**IF- Brookeland TX, John D Parker ADA Evaluation
County Rd 218**

Accessibility Evaluation

Inspection Date: 04/11/2023

Report Date: 02/01/2024

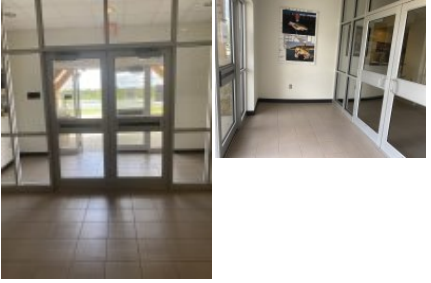
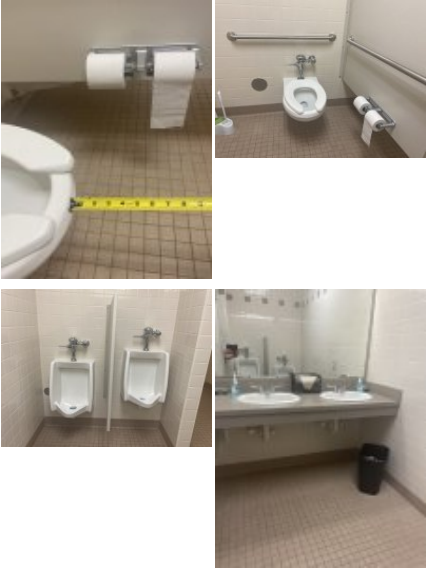
Finding Number	Area Description	Finding	As Built	Recommendation	Citation	Photos	Figure
1	Exterior of Property (Public): Visitors Center Parking Lot (2 Spaces) 1 Van 1 Car	Unlabeled space to (R) of van accessible parking meets dimension and sloping requirements for van accessible parking designation.	Space pictured meets requirements for van accessible parking stall.	Converting this space to van accessible designation by adding required markings, sign, and access aisles. Review parking stall and access aisle requirements https://www.access-board.gov/ada/#ada-208_2 https://www.access-board.gov/ada/#ada-502	2012 TAS Section: Recommended 2010 ADAS Section: Recommended 2015 ABAAS Section: Recommended		
2	Exterior of Property (Public): Visitors Center Parking Lot (2 Spaces) 1 Van 1 Car - Van Accessible Stall Front of Building	The parking sign is mounted too low. Parking space identification signs shall include the International Symbol of Accessibility. Signs identifying van parking spaces shall contain the designation "van accessible." Signs shall be 60 inches minimum above the finish floor or ground surface measured to the bottom of the sign.	measures at 58"	https://www.access-board.gov/ada/#ada-502_6	2012 TAS Section: 502.6 2010 ADAS Section: 502.6 2015 ABAAS Section: 502.6

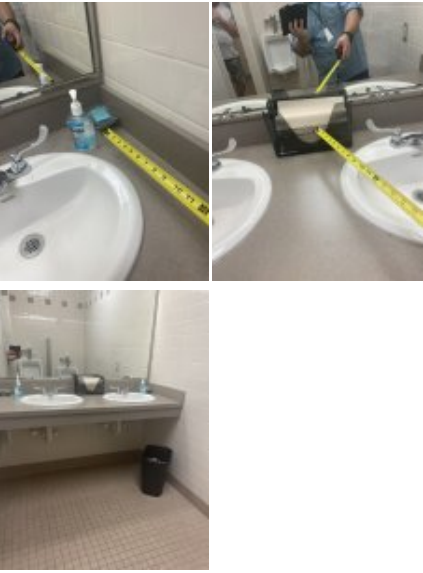
Finding Number	Area Description	Finding	As Built	Recommendation	Citation	Photos	Figure
4	Exterior of Property (Public): Pathway to Holding Ponds - TOUR	The accessible route contains loose gravel and/or surfaces that do not provide for a stable, firm slip resistant surface.	Parts of exterior pathways around holding ponds are in various states of deterioration.	https://www.access-board.gov/ada/#ada-302_1	2012 TAS Section: 302.1 2010 ADAS Section: 302.1 2015 ABAAS Section: 302.1

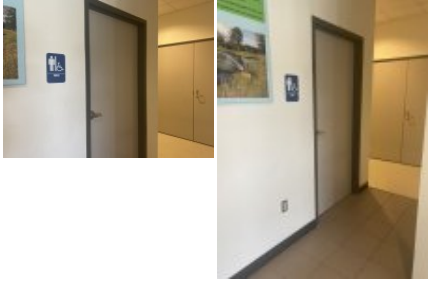
Finding Number	Area Description	Finding	As Built	Recommendation	Citation	Photos	Figure
5	Structures on Property (Public) - Tour/Public Componets : Visitors Center/Public Restrooms (Interior) - Entrance/Exit Doors	The door exceeds the maximum allowable opening force. Interior doors shall have a maximum opening force of 5 pounds. These forces do not apply to the force required to retract latch bolts or disengage other devices that hold the door or gate in a closed position.	Interior vestibule doors exceed 5lbs threshold for operation.	https://www.access-board.gov/ada/#ada-404_2_9	2012 TAS Section: 404.2.9 2010 ADAS Section: 404.2.9 2015 ABAAS Section: 404.2.9		
6	Structures on Property (Public) - Tour/Public Componets : Visitors Center/Public Restrooms (Interior) - Restroom (Men's)	The toilet paper is not installed within the compliant range. Toilet paper dispensers shall be 7 inches minimum and 9 inches maximum in front of the water closet measured to the centerline of the dispenser. The outlet of the dispenser shall be 15 inches minimum and 48 inches maximum above the finish floor and shall not be located behind grab bars. Dispensers shall not be of a type that controls delivery or that does not allow continuous paper flow. There shall be a clearance of 1 1/2 inches minimum below the grab bar.	Majority of restroom componets meet compliance. Finding only applies to inside dispenser, outside dispenser within compliant range.	https://www.access-board.gov/ada/#ada-604_7	2012 TAS Section: 604.7 2010 ADAS Section: 604.7 2015 ABAAS Section: 604.7

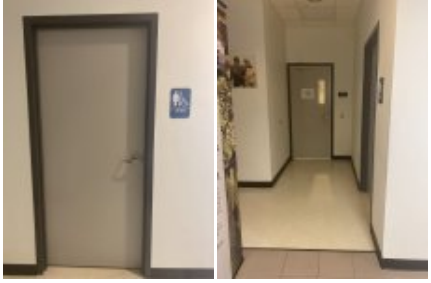
Finding Number	Area Description	Finding	As Built	Recommendation	Citation	Photos	Figure
10	Structures on Property (Public) - Tour/Public Componets : Visitors Center/Public Restrooms (Interior) - Restroom (Men's)	The door exceeds the maximum allowable opening force. Interior doors shall have a maximum opening force of 5 pounds. These forces do not apply to the force required to retract latch bolts or disengage other devices that hold the door or gate in a closed position.	restroom door exceed 5lbs pressure required to operate	https://www.access-board.gov/ada/#ada-404_2_9	2012 TAS Section: 404.2.9 2010 ADAS Section: 404.2.9 2015 ABAAS Section: 404.2.9		
11	Structures on Property (Public) - Tour/Public Componets : Visitors Center/Public Restrooms (Interior) - Restroom (Women's)	The toilet paper is not installed within the compliant range. Toilet paper dispensers shall be 7 inches minimum and 9 inches maximum in front of the water closet measured to the centerline of the dispenser. The outlet of the dispenser shall be 15 inches minimum and 48 inches maximum above the finish floor and shall not be located behind grab bars. Dispensers shall not be of a type that controls delivery or that does not allow continuous paper flow. There shall be a clearance of 1 1/2 inches minimum below the grab bar.	Majority of restroom componets meet compliance. TP dispenser is mounted out compliant range, over 12"	https://www.access-board.gov/ada/#ada-604_7	2012 TAS Section: 604.7 2010 ADAS Section: 604.7 2015 ABAAS Section: 604.7

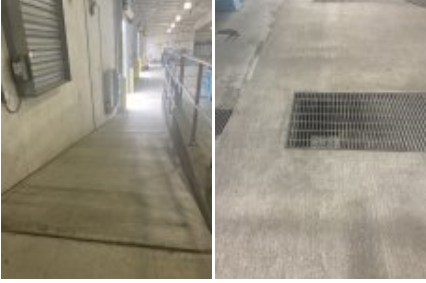
Finding Number	Area Description	Finding	As Built	Recommendation	Citation	Photos	Figure
13	Structures on Property (Public) - Tour/Public Componets : Visitors Center/Public Restrooms (Interior) - Restroom (Women's)	The water closet compartment is missing a loop handle on the one side of the door. Water closet compartments must be equipped with a door that has a loop or U-shaped handle on both sides of the door near the latch. The latch must be flip-over style, sliding or other hardware not requiring the user to grasp or twist.	N/A	https://www.access-board.gov/ada/#ada-604_8_1_2	2012 TAS Section: 604.8.1.2 2010 ADAS Section: 604.8.1.2 2015 ABAAS Section: 604.8.1.2		
14	Structures on Property (Public) - Tour/Public Componets : Visitors Center/Public Restrooms (Interior) - Restroom (Women's)	The coat hook is installed greater than 48 inches above the finished floor. Where a forward reach is unobstructed, the high forward reach shall be 48 inches maximum above the finished floor.	Measured at 52"	https://www.access-board.gov/ada/#ada-308_2_1 https://www.access-board.gov/ada/#ada-308_2_2	2012 TAS Section: 308.2.1 2010 ADAS Section: 308.2.1 2015 ABAAS Section: 308.2.1
